Re: Amended Application for Initial Construction Permit
Surface Impoundment No. W1970450047-2 (Pond 2)
Midwest Generation Joliet #29 Station
#1970455041
1800 Channahon Road/Joliet, IL/Cook County

Enclosed please find the amended permit text including revised closure drawings 3 and 4, revised specifications and revised final closure plan for the previously submitted January 28, 2022 Pond 2 Application for Initial Construction Permit.

AMENDED APPLICATION FOR INITIAL CONSTRUCTION PERMIT

**Originally Submitted: January 28, 2022
Amended: October 2025**

AMENDED SITE TRANSPORTATION MAP	
JOLIET #29 GENERATING STATION JOLIET, ILLINOIS	
Scale: 1" = 250'	Date: September 11, 2023
KPRG Project No. 19620	FIGURE 2

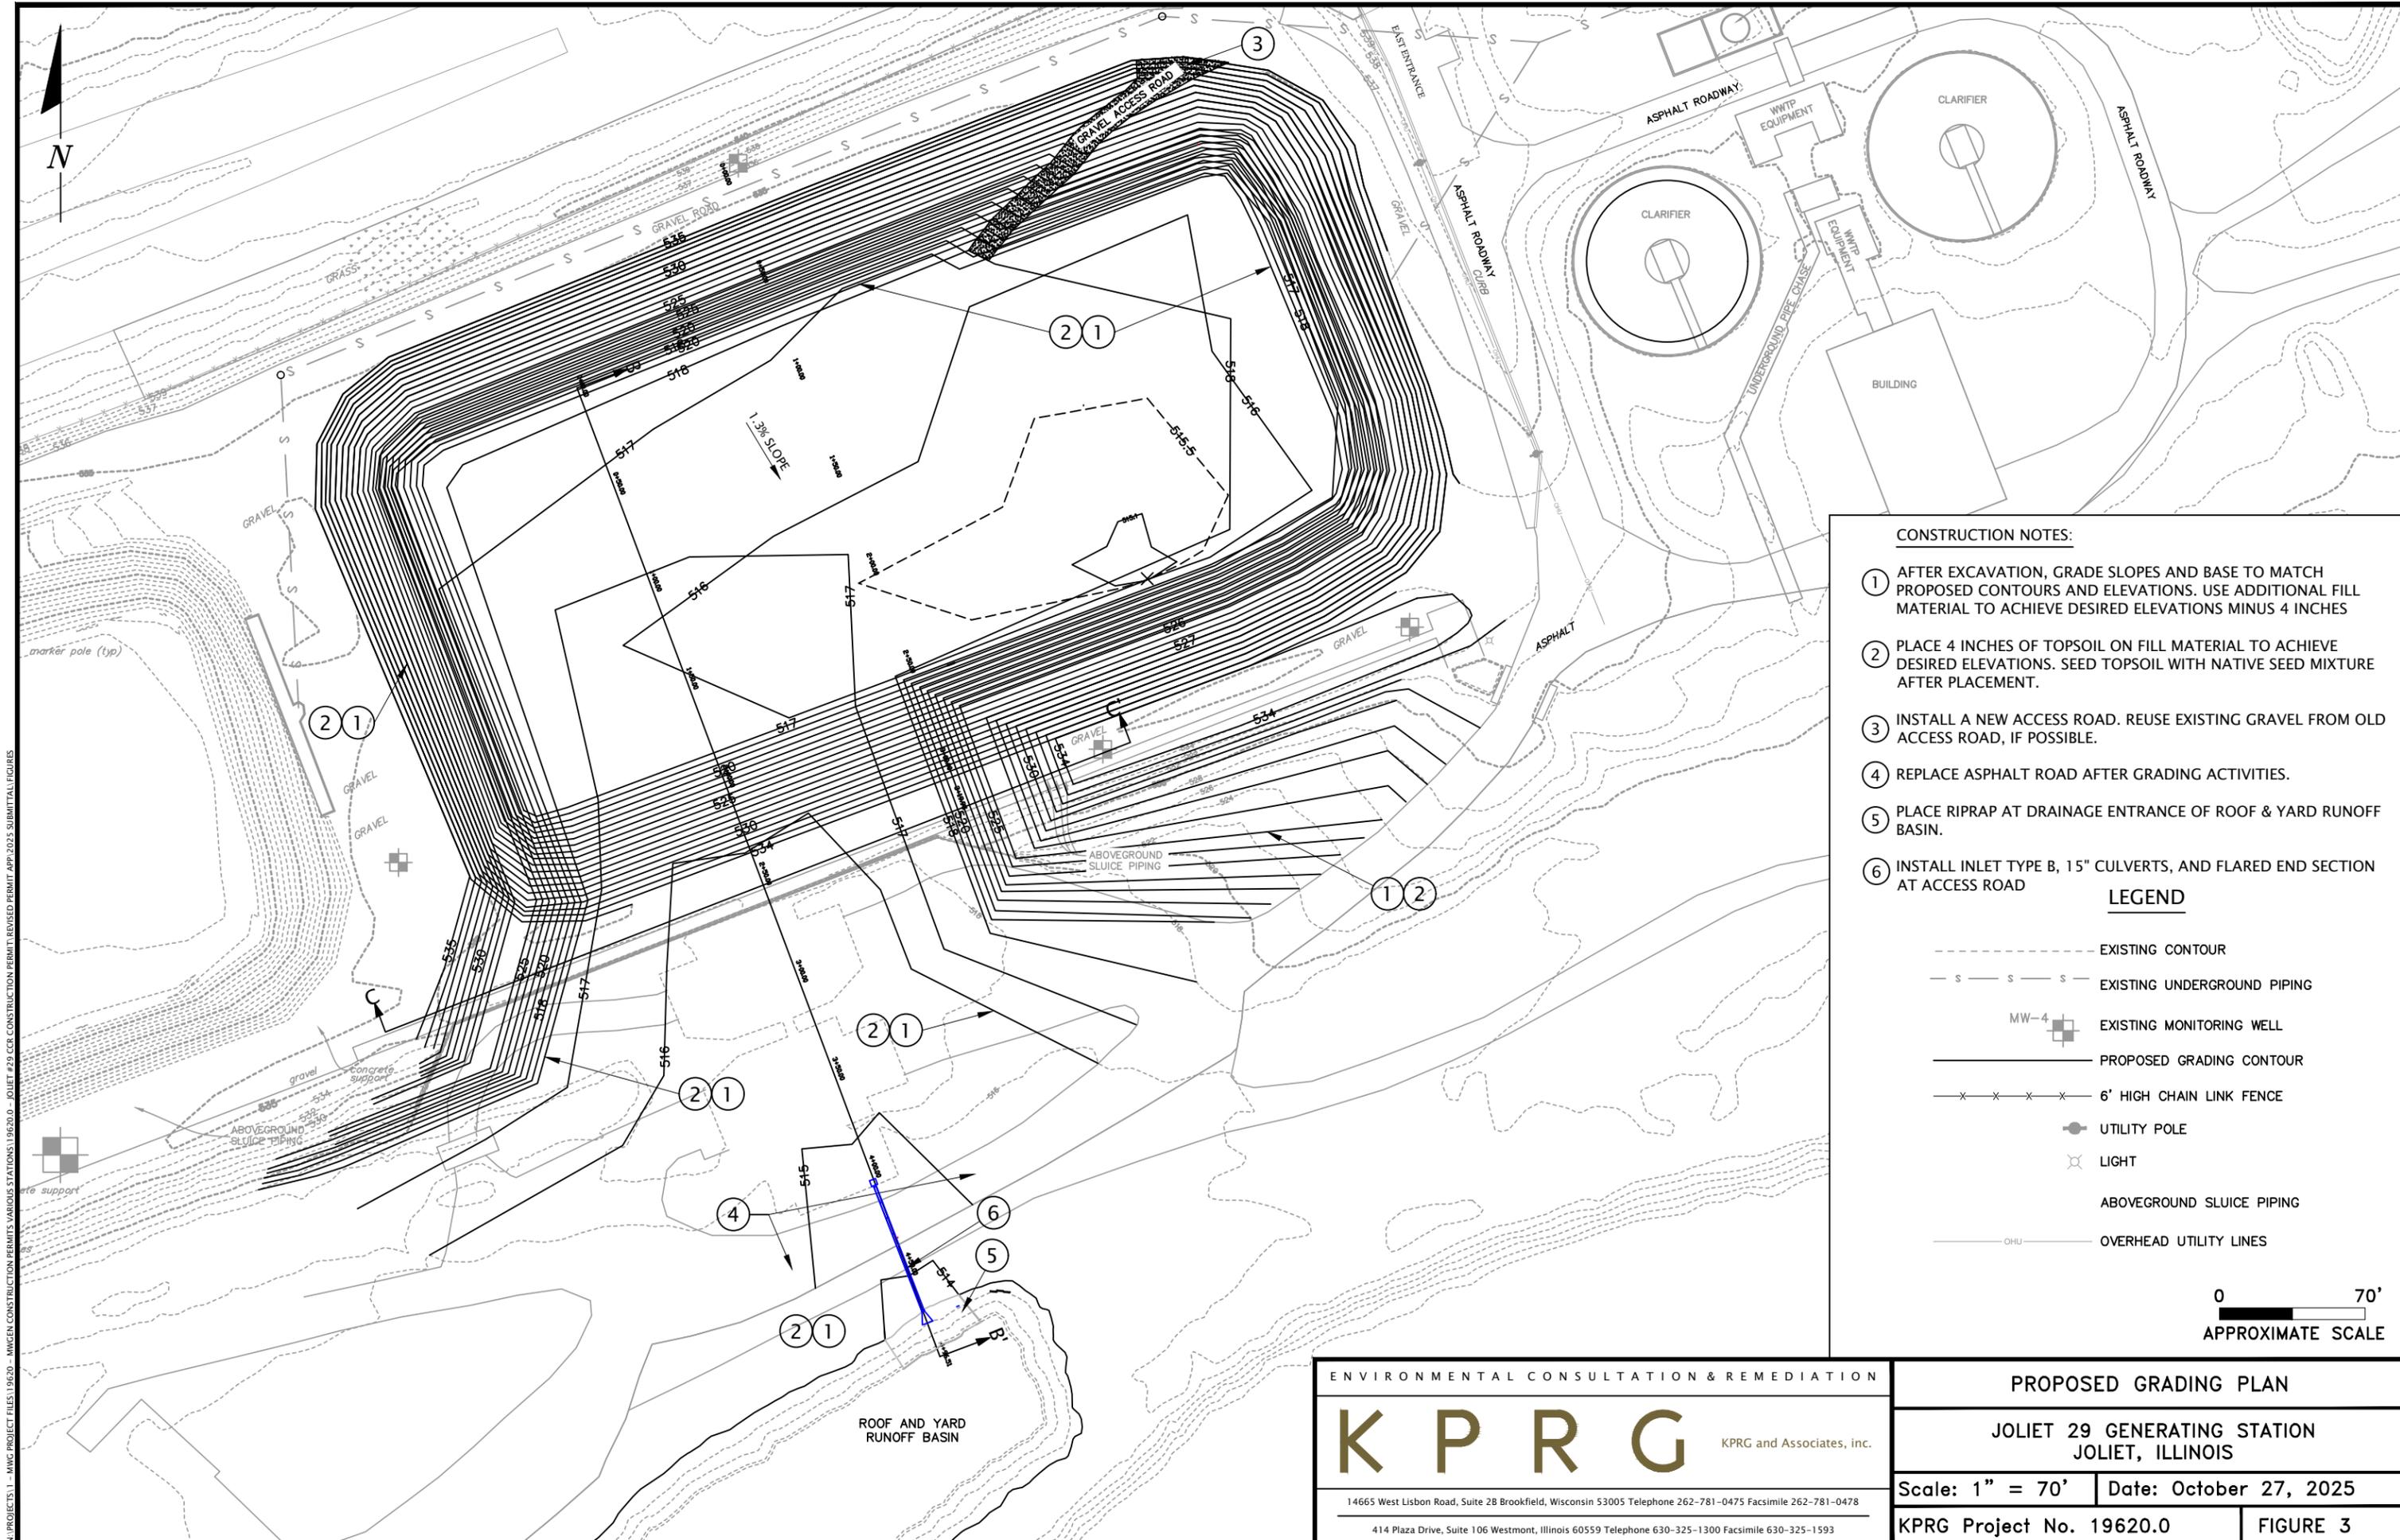
REVISED FIGURE

Figure 2 Pond 2 Access Roads

KPRG Project No. 19620.0 FIGURE 3

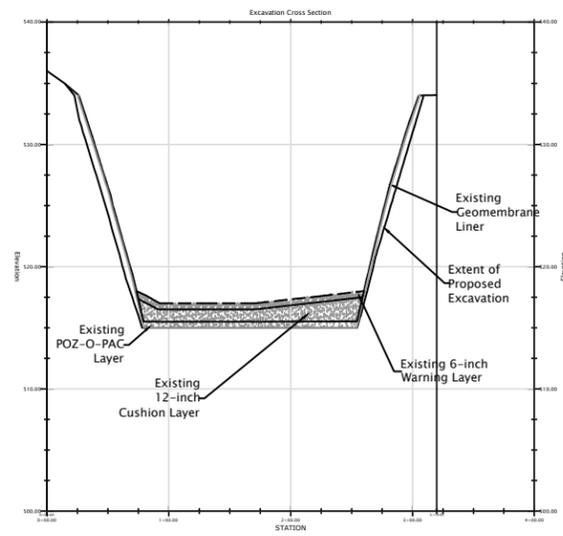
- ① AFTER EXCAVATION, GRADE SLOPES AND BASE TO MATCH PROPOSED CONTOURS AND ELEVATIONS. USE ADDITIONAL FILL MATERIAL TO ACHIEVE DESIRED ELEVATIONS MINUS 4 INCHES
- ② PLACE 4 INCHES OF TOPSOIL ON FILL MATERIAL TO ACHIEVE DESIRED ELEVATIONS. SEED TOPSOIL WITH NATIVE SEED MIXTURE AFTER PLACEMENT.
- ③ INSTALL A NEW ACCESS ROAD. REUSE EXISTING GRAVEL FROM OLD ACCESS ROAD, IF POSSIBLE.
- ④ REPLACE ASPHALT ROAD AFTER GRADING ACTIVITIES.
- ⑤ PLACE RIPRAP AT DRAINAGE ENTRANCE OF ROOF & YARD RUNOFF BASIN.
- ⑥ INSTALL INLET TYPE B, 15" CULVERTS, AND FLARED END SECTION AT ACCESS ROAD
